**RAI Volume 2, Chapter 2.1.1.3, Third Set, Number 17:**

Figure 1. Location of Potential Flood Water Buildup and Subsurface Facility Features in Immediate Vicinity

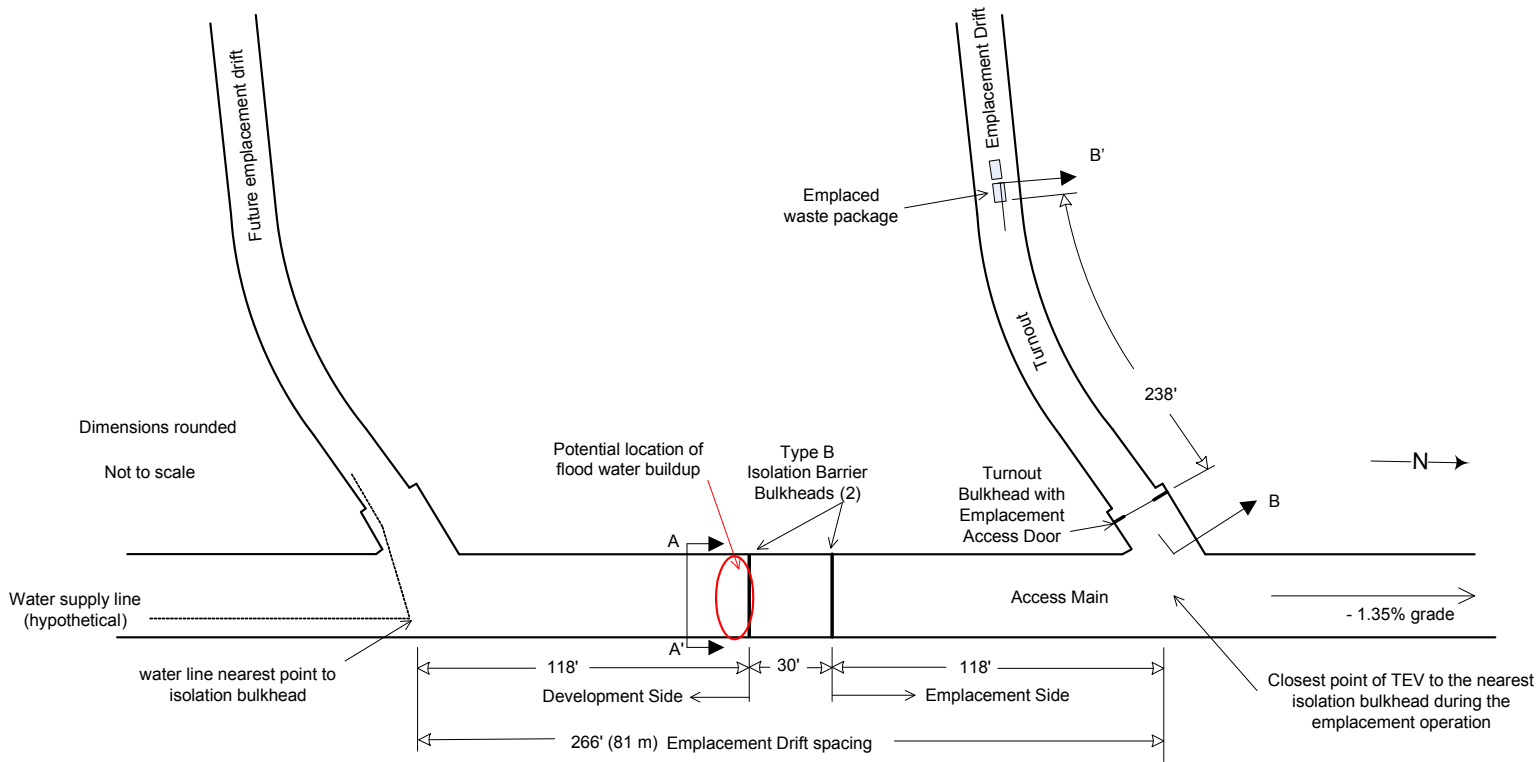
- (a) Justify why the doors of the emplacement drifts, discharge pump, construction barrier, and shotcrete seal would not be classified as items important to safety in SAR Table 1.9–1 Preclosure Safety Classification of SSCs. As part of the screening argument for internal flooding in the subsurface facilities, DOE has identified emplacement drift doors that would prevent water splash from contacting waste packages, barriers at the front of each emplacement drift, a discharge pump that would pump water out of the tunnel, a construction barrier, and shotcrete seal (BSC, 2008). In addition, on page 101 of BSC (2008), DOE indicates that, “In the event of a flood, portal security personnel can isolate flow to the tunnel (underground communications are provided during construction operations).”

Figures 1 and 2 illustrate a typical configuration of a Type B isolation barrier separating the emplacement area from the development area, distances from the barrier to the other adjacent repository openings, corresponding terminology as used in the SAR, and access main grade for the Panel 1 and Panel 2 access main. Depiction of the water supply line in Figure 1 is representational, as the SAR does not include such design information for construction activities. The Type B isolation barrier consists of two bulkheads forming an airlock compartment between the development and emplacement sides of the emplacement panel being developed. Figure 1 also shows the location of the emplacement access doors that are installed within a single bulkhead at the entrance to the turnout, as described in SAR Section 1.3.5.

Figure 3. Waste Package Location in TEV during Transportation for Emplacement

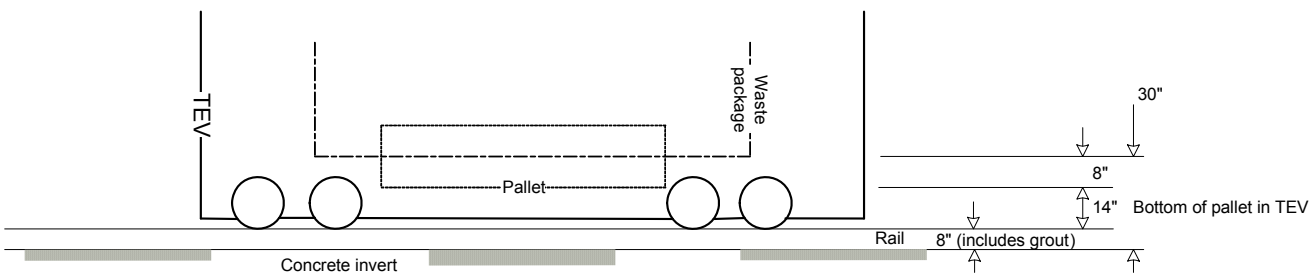
- (d) Justify why a loaded Transportation and Emplacement Vehicle (TEV) near the intersection of the access main and emplacement drift would not be affected during an internal flooding event. This is needed to assess whether an internal flooding event can affect a loaded TEV during transit in the subsurface facility.

Figure 3 represents the transport and emplacement vehicle (TEV) physical setting in the access main at its closest point of approach (approximately 118 ft) to the nearest isolation barrier bulkhead, as identified in Figure 1. This figure also provides the location of the waste package inside the TEV relative to the access main top-of-invert and top-of-rail elevations.

Given the calculated water depths, the water would not contact the waste package being transported inside the TEV (Figure 3). This depth of water at the intersection of the access main and the turnout would not be sufficient to overcome the elevation rise to the emplacement drift level (Figure 4); therefore, the water would not enter the emplacement drift.

Figure 4. Placement Drift Relationship at Location B–B' Referenced in Figure 1

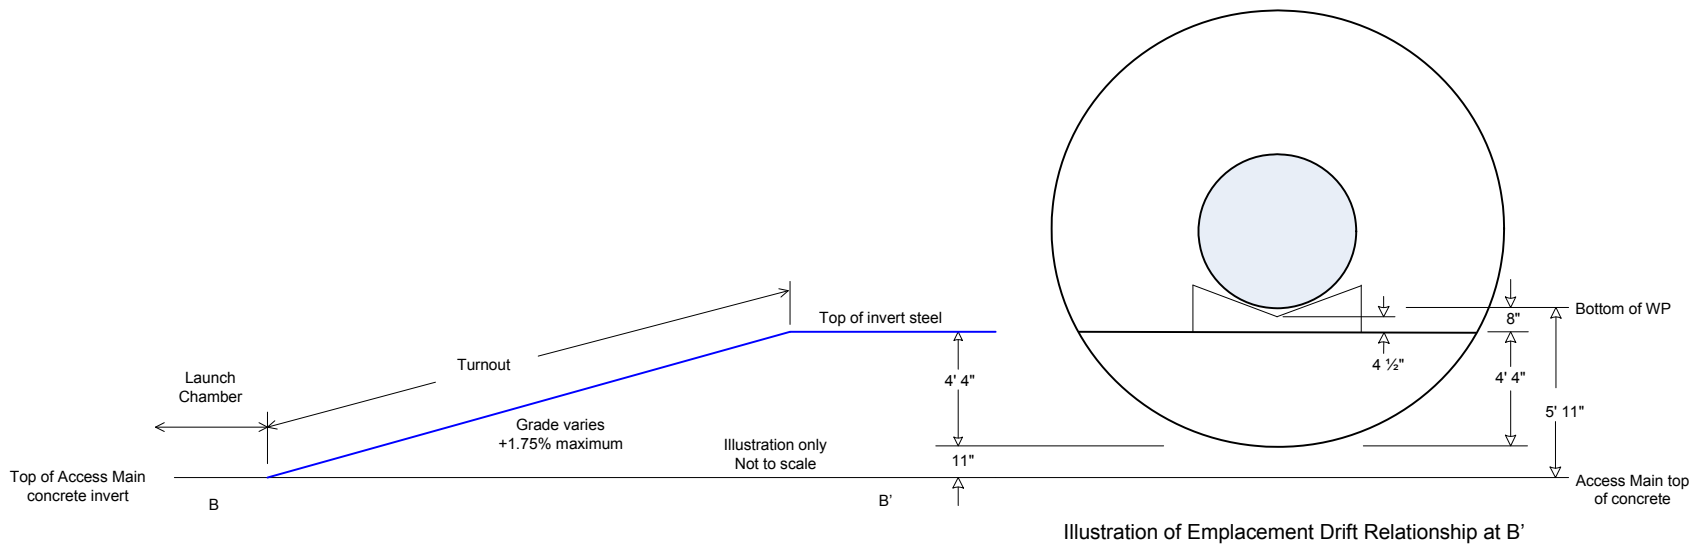
- (c) Justify the conclusion that the amount of water available for internal flooding is insufficient to rise to the waste package elevation in the emplacement drifts. This is needed to assess whether failure of water supply pipes to the Tunnel Boring Machine could cause water build up high enough on the construction side of the isolation barrier. The accumulated water may flow down the access main to the emplacement side and enters the drifts with emplaced waste packages. Calculations provided in BSC, 2008, Section 6.04 seems to assume that the isolation barrier is always at the intersection of the emplacement drift and access main, which is inconsistent with the information in SAR Section 1.3.1.2.7 and SAR Figure 1.3.1–12. The calculations could have underestimated the potential maximum water levels as a result of this assumption.

Figure 4 illustrates the waste package elevation when placed on a pallet in an emplacement drift and its position relative to the top-of-invert elevations for the emplacement drift, turnout, and access main.
